# City of Ottawa

## Main Street Road Safety Audit

FINAL REPORT

**Finding #2: Reserved Bicycle Lane Signs Pointing to Sidewalk – Severity Rating: Medium**

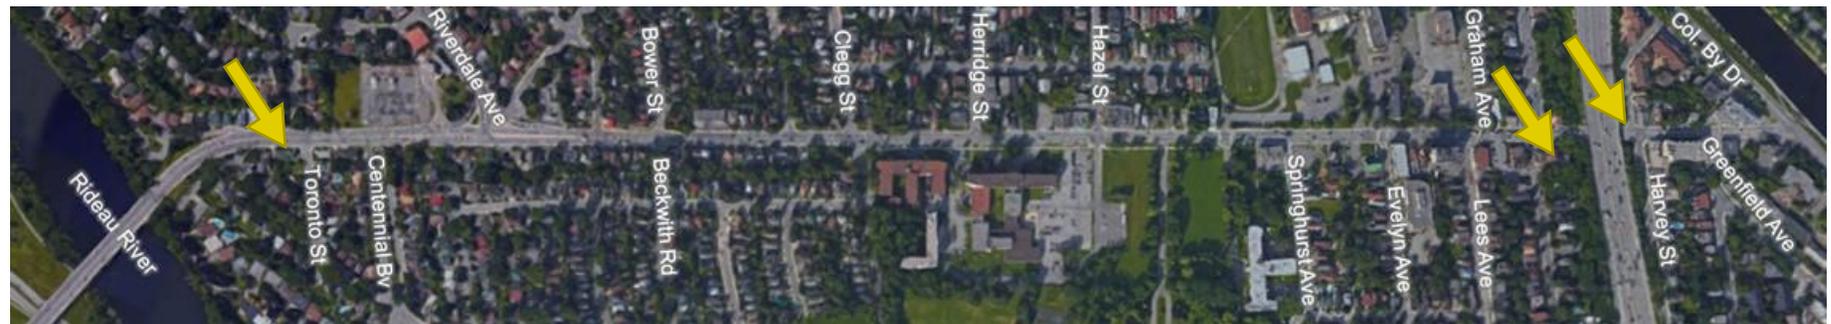
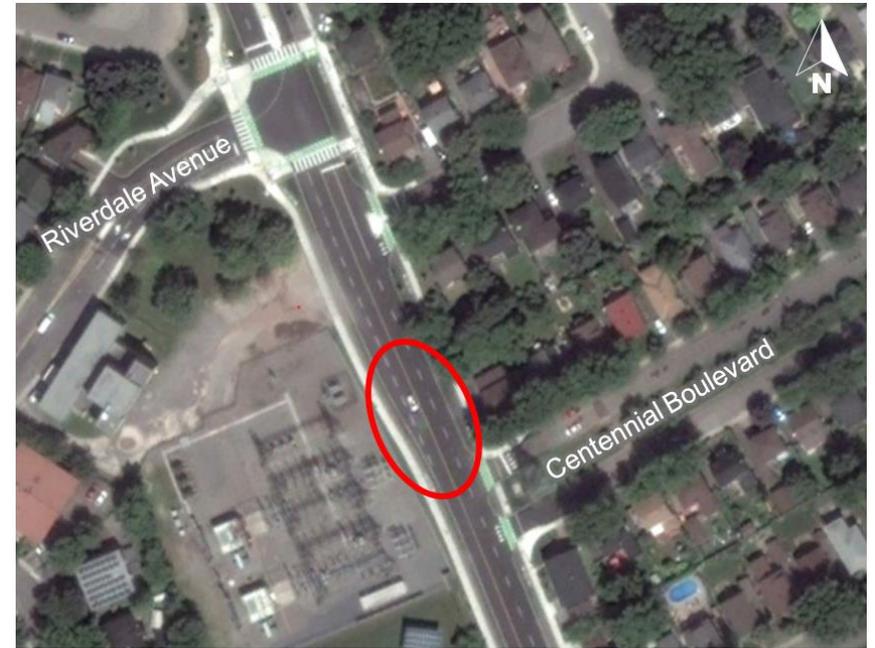
At some locations, the ground mounted Reserved Bicycle Lane signs are installed adjacent to the sidewalk. This makes the diagonal arrow on the sign point at the sidewalk, as opposed to the cycle track. This was observed at three locations along Main Street: northbound near Toronto Street and near Hawthorne Avenue, and southbound near Harvey Street.

Where this condition occurs, the Reserved Bicycle Lane signs should be mounted to the left of the cycle track, such that the diagonal arrow points at the cycle track. Although this may not be a typical standard, it provides a more clear indication of where cyclists should ride.

Moving the signs to the left of the cycle track would increase the driver workload, particularly in locations where there are already other signs posted nearby (such as in the photo above). Additionally, primary signs are typically placed on the right side of a facility, making this sign placement consistent with what cyclists may expect. No changes are planned since it is not expected that the sign placement would be the cause of conflicts or collisions.

**Finding #3: Lane End Near Intersection – Severity Rating: Low**

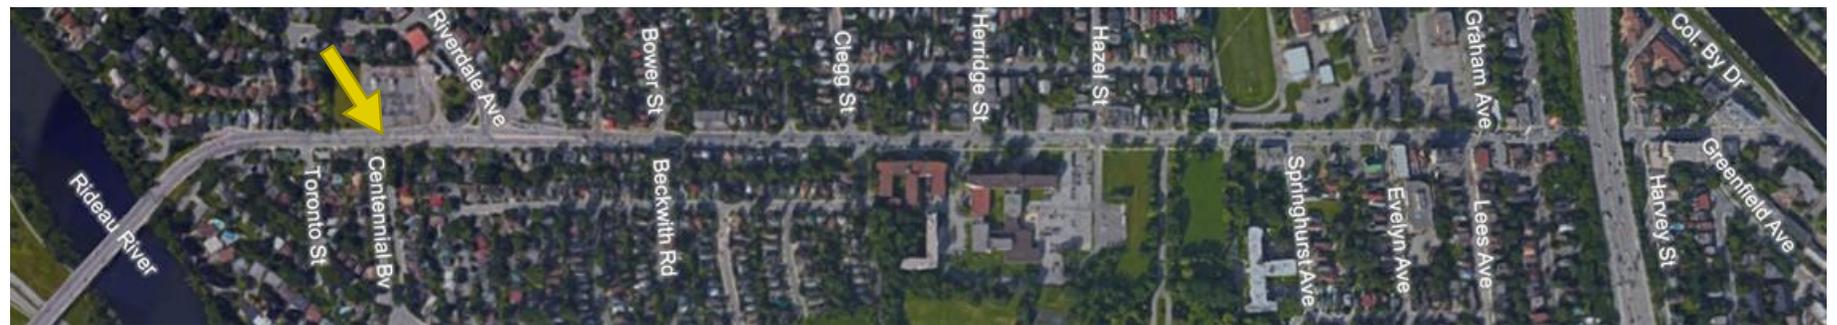
A second southbound through lane is introduced on Main Street's approach to Riverdale Avenue. This lane terminates approximately 100 metres south of the intersection, with its taper ending near Centennial Boulevard. During the PM peak hour, southbound vehicles would block traffic while waiting for gaps to turn left onto Centennial Boulevard. This has the potential to contribute to rear end collisions.

If feasible, consideration should be given to extending the second southbound lane on Main Street past the intersection with Centennial Boulevard. This would allow through vehicles to use the curb lane to bypass vehicles waiting to turn left on Centennial Boulevard. If not feasible, rear end collisions and near misses should be monitored over time and, if significant, consideration may be given to restricting left-turns onto Centennial Boulevard during peak hours. Although restricting southbound left-turns at Centennial Boulevard would simply migrate left-turners to Toronto Street; however, this movement at Toronto Street is less complex, given it is not in close proximity to the end of a taper and is further away from the busier Riverdale Avenue.

The length of the lane is constrained by infrastructure (a barrier wall) at the hydro station, therefore extending the lane to the south is not considered to be feasible. During design, the City identified that the second (curbside) southbound receiving lane was beneficial for traffic operations (added capacity at the signalized intersection), therefore shortening the lane is also not considered to be feasible.

**The City of Ottawa will monitor collisions (once 3-year data is available) at this location and will consider changes if collision history indicates a serious safety issue at this location.**

### Finding #4: Offset Bicycle Crossing – Severity Rating: Extreme

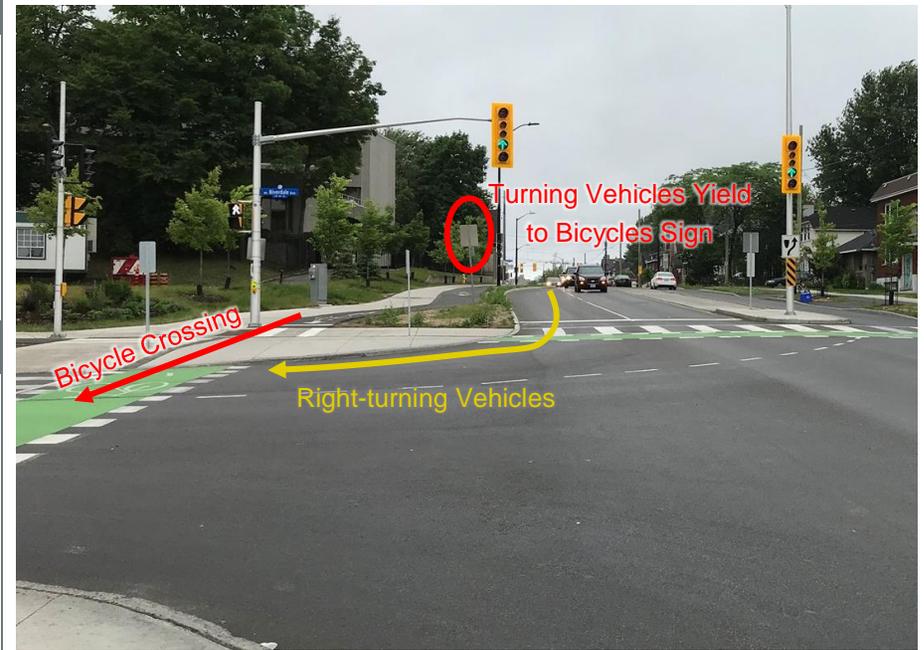
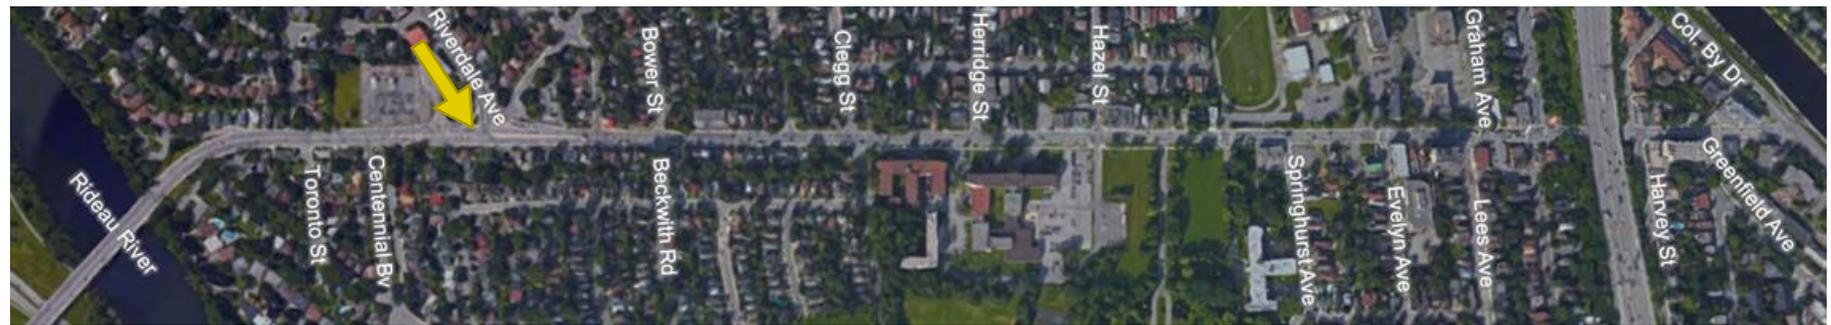
The southbound bicycle crossing at Main Street & Riverdale Avenue is offset from the intersection by approximately 4.50 metres. Although a “Turning Vehicles Yield to Bicycles” sign is provided on the curbside at this location; however, the offset could make it difficult for right-turning drivers to see approaching cyclists.

It is likely not possible to realign the north-south bicycle crossing closer to the intersection, since there are also east-west crossings, sidewalks and signal poles in this area. To reinforce the presence of the bicycle crossing, a second Turning Vehicles Yield to Bicycles sign could be provided on the signal mast-arm for the southbound direction. The City can then monitor driver behaviour to determine if the second sign is effective. If not effective, innovative solutions could be considered (e.g. signs with LED contours or other means to make the signs more conspicuous).

The design of this intersection was based on the “bend-out” cycle track design which is popular in Europe and has been becoming increasingly popular in North America. A “bend-out” design pushes the crossride and cycle track away from the intersection, such that there is a distance of at least 2.0m (6.0m preferred) between the tangent of the road and the nearest portion of the crossride (or crosswalk). Engineering literature have indicated that the benefits of a “bend-out” design include:

As bend-out design is not yet common within the City’s limits, motorists may not yet be familiar with how to best interact with the crossrides in this type of design. **The City will monitor operations and collisions at this intersection, and will react accordingly. The City will also complete a conflict analysis for this location to identify potential near-misses.**

At this time, an additional sign is not recommended since the sign would add to driver workload and may or may not actually provide a benefit. Currently there are two “yield to cyclist” (Rb-37 TAC) signs: A ground-mounted sign on the nearside of the intersection and a secondary sign mounted on the signal pole on the southwest corner (the pole which houses the pedestrian push button for the north-south crosswalk).

**Finding #7: Inconspicuous Sign on Bicycles' Path + Conflict Between Pedestrian and Bicycle Paths – Severity Rating: Medium**

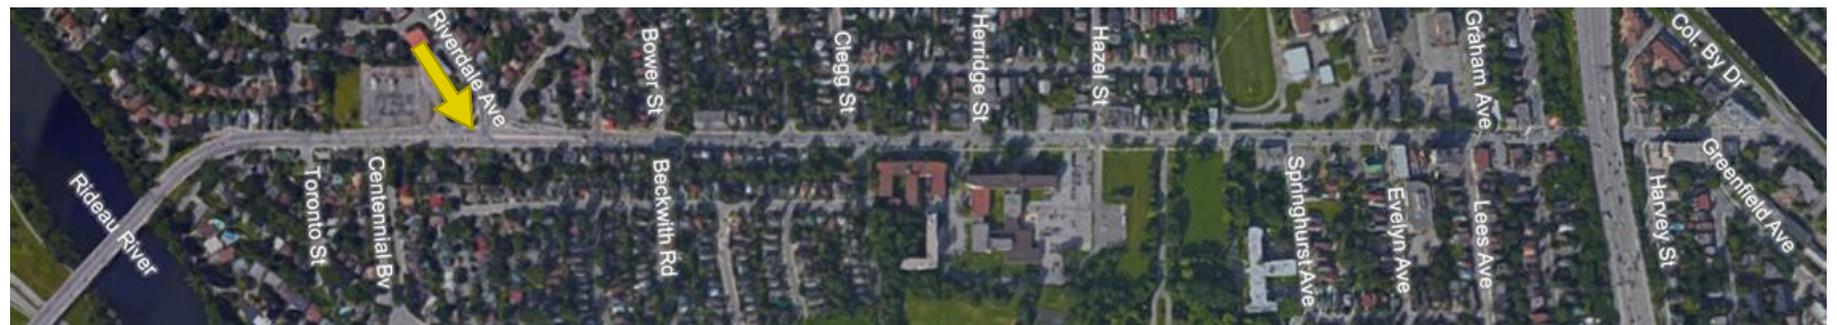
At the southwest corner of Main Street & Riverdale Avenue, a sign intended for north-south pedestrians and cyclists (to keep left/right, respectively) is located in the path of eastbound cyclists. This sign is difficult to see when approaching in the eastbound direction, and could be struck by cyclists.

Additionally, the pedestrian path along the west sidewalk intersects the eastbound cyclist's path. It may not be clear to all pedestrians that they are supposed to wait for the Walk signal indication on the tactile plate (circled in red). Pedestrians could proceed to wait near the curb, while eastbound cyclists have a green light, which could contribute to a bicycle-pedestrian collision.

Relocate the "Keep Left/Right" sign further north so it is outside of the potential path of eastbound cyclists.

Additionally, consider providing signage indicating where northbound pedestrians should stop to wait for the Walk signal indication before crossing Riverdale Avenue.

The eastbound cycling facility theoretically bends toward the south (away from the sign) at this location, since cyclists must either bend towards the eastbound cycle track, or turn right to proceed south on Main Street. The sign therefore is not actually in the path of a cyclist if the cyclist is following the facilities as intended. Regardless, to improve visibility of the sign post, **the City install retroreflective material on the post.**

It is noted that the cycling facilities are not well delineated at this location, since the asphalt cycle tracks lead into concrete facilities. In order to better delineate this space, **the City will be installing additional thermoplastic to show there the cycling facilities are located.** This will also assist in providing information to pedestrians regarding where they should wait (when waiting for the signal).

**Finding #8: Light Fixture Encroaching on Cycle Track – Severity Rating: Medium**

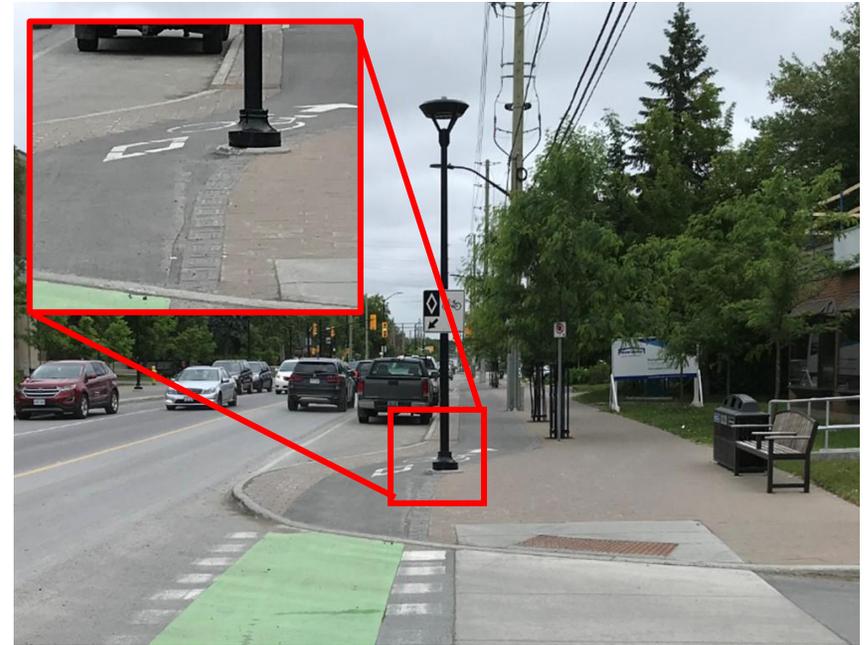
At the southwest quadrant of Main Street & Herridge Street, there is a light fixture encroaching the cycle track. This is located at the beginning of a jog to the right, and cyclists could potentially strike the post with their shoulder. This light fixture appears to be the only one of this type on the west side of Main Street (more are present on the east side, in front of Saint Paul University). It also seems to have a more decorative function, rather than providing required illumination (e.g. overhead lights are provided on adjacent hydro poles along the west side).

Consider removing this light fixture.

The City will review the lighting needs for this area and will consider whether it would be appropriate to remove the light fixture.

### Finding #13: Cluttered Signage – Severity Rating: Low

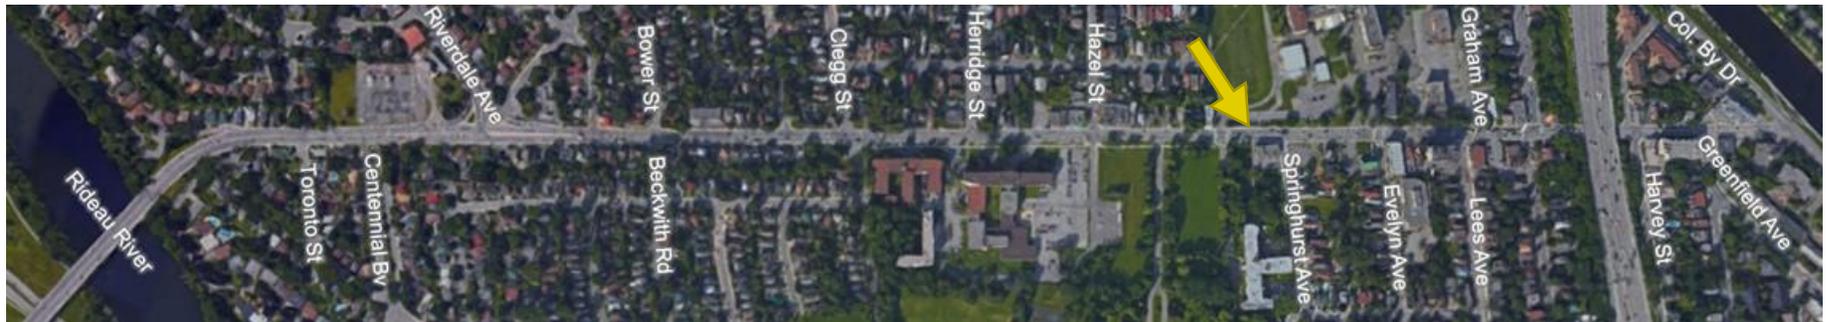
At several locations, particularly close to intersections, there are multiple signs installed on the same support or in close proximity to each other. These signs compete for users' attention, and important messages can be overlooked.

Where possible, rearrange signage to reduce clutter. For example, in the picture shown, the "Turning Vehicles Yield to Cyclists" sign could be relocated to the left side of the cycle track on its own support, and the bus stop sign could be relocated above the parking regulations on the hydro pole.

The City will review signage along the corridor to identify if there is any signage that should be changed due to sign clutter and driver workload. It should be noted however that in situations such as the one shown above, it is generally accepted that the signs can be located in near proximity to each other if required and/or if the general message of the signs are compatible.

**Finding #14: Potential for Conflict between Bus Passengers and Cyclists – Severity Rating: Medium**

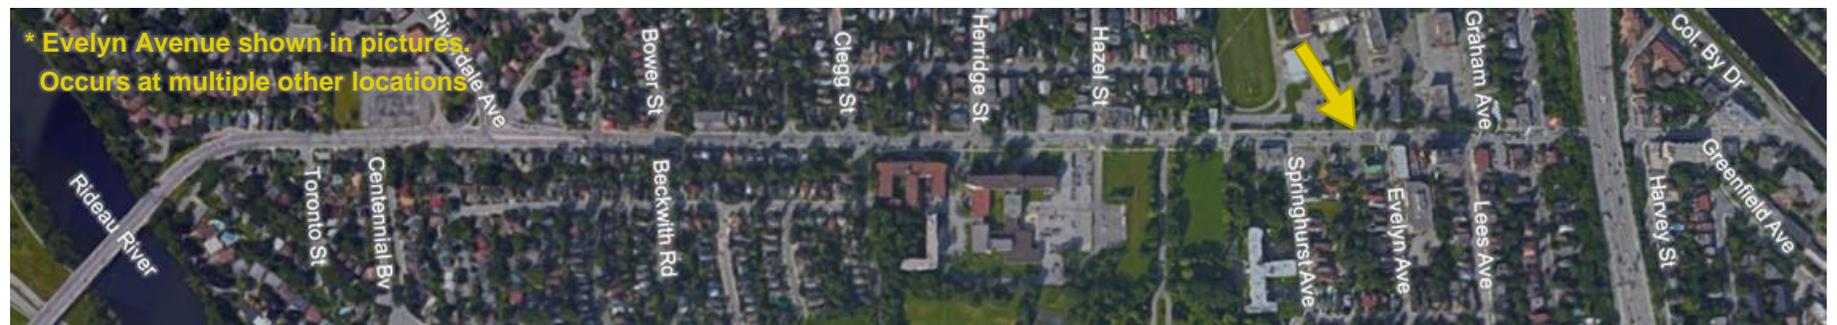
Pavement Markings with a zigzag pattern are provided on the cycle tracks, at bus stops along Main Street, to indicate to cyclists the areas where pedestrians are expected to cross the cycle track. In advance of these areas, a pictographic sign (shown in the top right red box) indicates to cyclists the requirement to yield to pedestrians. However, the message on these signs (which are not standard signs) may not be completely clear to cyclists, particularly at locations where they are installed close to bicycle signals (as illustrated in the bottom right red box).

Additionally, one bus was observed offloading passengers outside the areas designated bus stops (i.e. areas with zigzag patterns). This was observed during the PM peak hour, when congestion created long queues. A passenger was seen getting off the bus and across the cycle track without looking for approaching cyclists.

Consider revising the sign pictogram to clearly indicate that the message relates to pedestrians getting on an off buses.

As opposed to zigzag pavement markings, consider pictographic pavement markings (e.g. yield sign pavement markings, “watch for pedestrians” message markings, etc.)

The signs and markings implemented at this location are based on the design that the City of Ottawa was using while the Main Street facilities were being designed. Since this time, there have been changes made to the standard design that the City uses. OC Transpo is currently finalizing the recommended standard design. The input received at this location will be provided to OC Transpo for their information in creating the new design standard.

### Finding #15: Inappropriate Cyclist Behaviours – Severity Rating: Medium

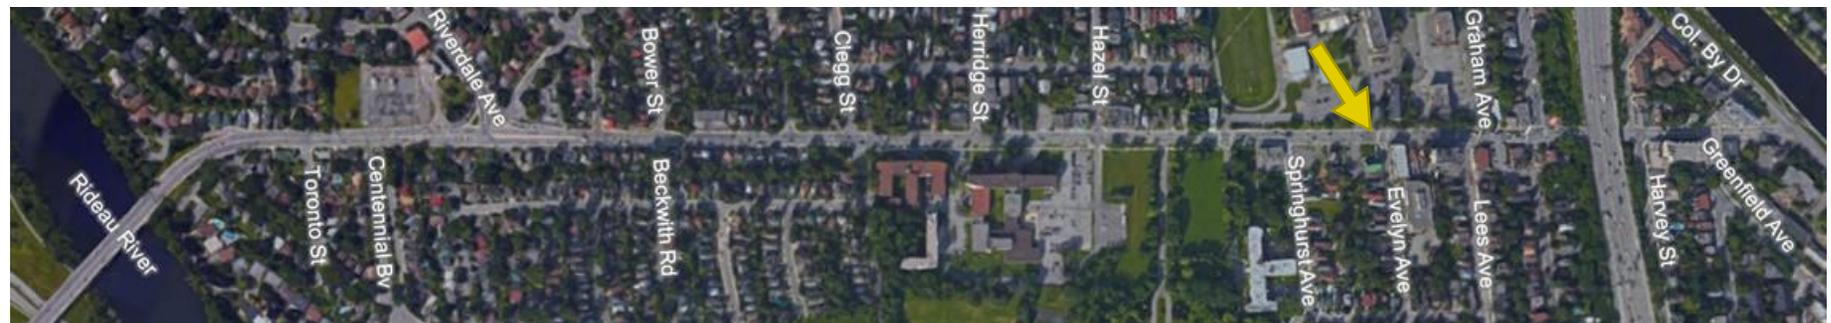
Several cyclists were observed riding on the sidewalk and travelling the wrong way on the provided cycle tracks, as well as crossing Main Street using crosswalks without dismounting. One cyclist was asked if there was a specific reason why they preferred using the sidewalk in the opposite direction of the cycle track, and she indicated that it felt safer than riding under the construction scaffolding on the east side of Main Street, near Oblate Avenue.

Other inappropriate cyclist behaviours included disobeying the red light at bicycle signals. This was observed at several locations within the study area, with one of the most critical locations being the southbound approach to Riverdale Avenue, where the downgrade can encourage high bicycle speeds.

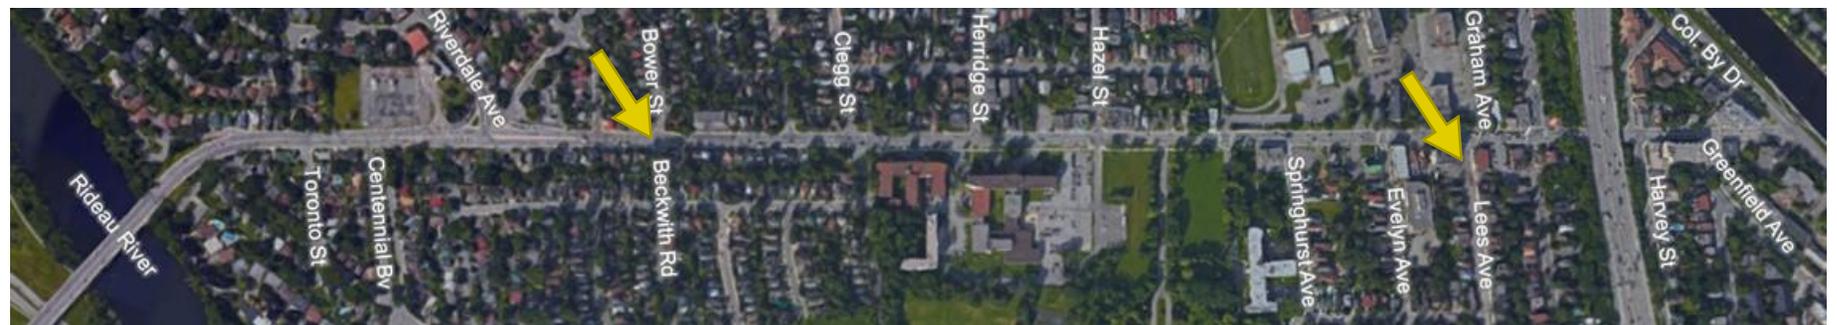
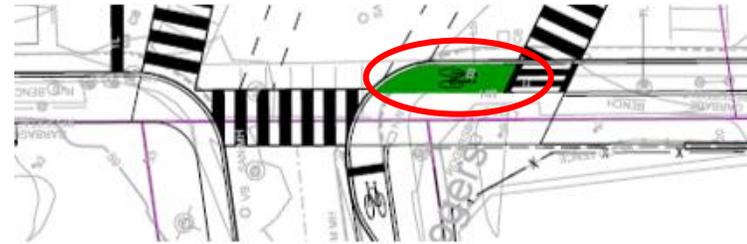
Bike boxes are provided at the intersection of Main Street and Lees Avenue to assist cyclists to turn left from Main Street onto Graham Avenue. The bike box is located between the stop bar for motor vehicles and the crosswalk on Lees Avenue. This configuration requires cyclists to move across the pedestrian path, across the crosswalk to get to the bike box.

Additionally, the right-turn volumes from Lees Avenue onto Main Street are high during the peak hours and, most of the time, vehicles stand on the bike box while waiting to turn right-on-red. This configuration creates conflicts between cyclists and pedestrians, and between cyclists and motor vehicles.

A similar configuration exists at Bower Street/Beckwith Street; however, the potential for conflicts is lower due to the lower volume of vehicles and pedestrians.

- The bike box serves both as a facility for cyclists making a northbound left turn, and as a facility for cyclists travelling westbound on Lees Avenue.
- Cyclists waiting in the bike box are protected from through (northbound) traffic on Main Street.
- Cyclists waiting in the bike box are protected from the sweeping path of southbound left turning vehicles on Main Street (turning onto Lees Avenue)
- The location of the bike box allows for cyclists to be detected using the same loop system as westbound through vehicles on Lees Avenue.

**The City will monitor operations to identify whether “no right on red” should be provided.**

### Finding #19: Left-turning Bicycles May Block Through Bicycles – Severity Rating: Medium

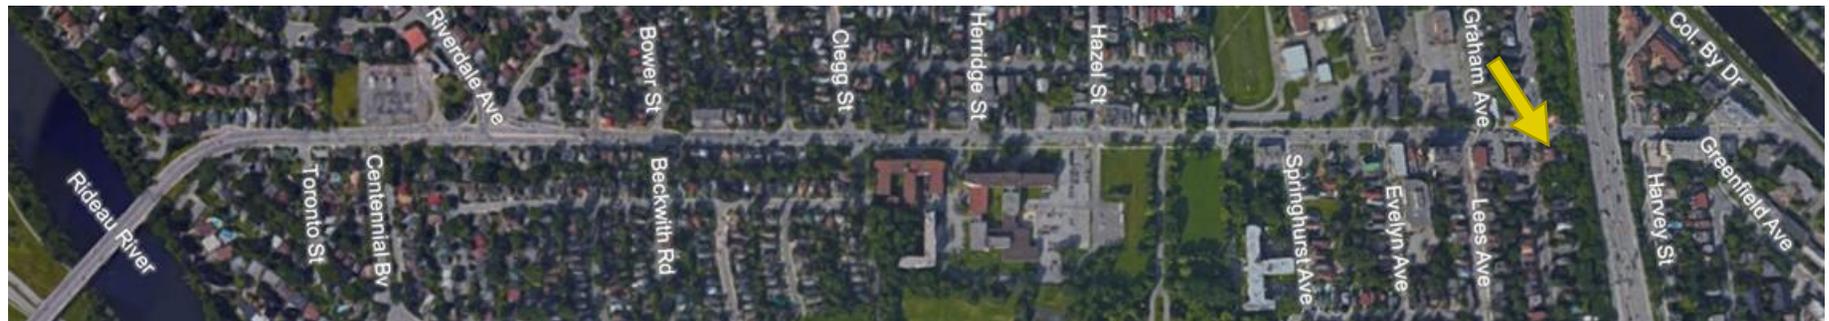
Consider rearranging the configuration in this area. Potential modifications include moving the stop bar closer to the curb and/or modifying the area indicated by the green arrow in the picture to the right, using green coloured pavement, to better define the left-turn waiting area.

The stop bar will not be moved closer to Main Street since a certain amount of clear space should be provided between the roadway and the stop bar (in order to ensure that cyclists do not encroach on the roadway when they do not have right-of-way). No changes are recommended to the “eyebrow” island (shown by the green arrow) since this is considered an essential component of protected intersection design and because cyclists would not be angled appropriately to see the traffic light if they were located where the eyebrow island currently exists. Additionally, it is not feasible to shift the cycling facility further east (to obtain more room for cyclist storage) since there needs to be adequate space for pedestrian facilities. Consequently, there is considered to be no extra space available to provide additional storage for turning cyclists. Cyclists approaching this location are expected to yield to any cyclist that is ahead of them.
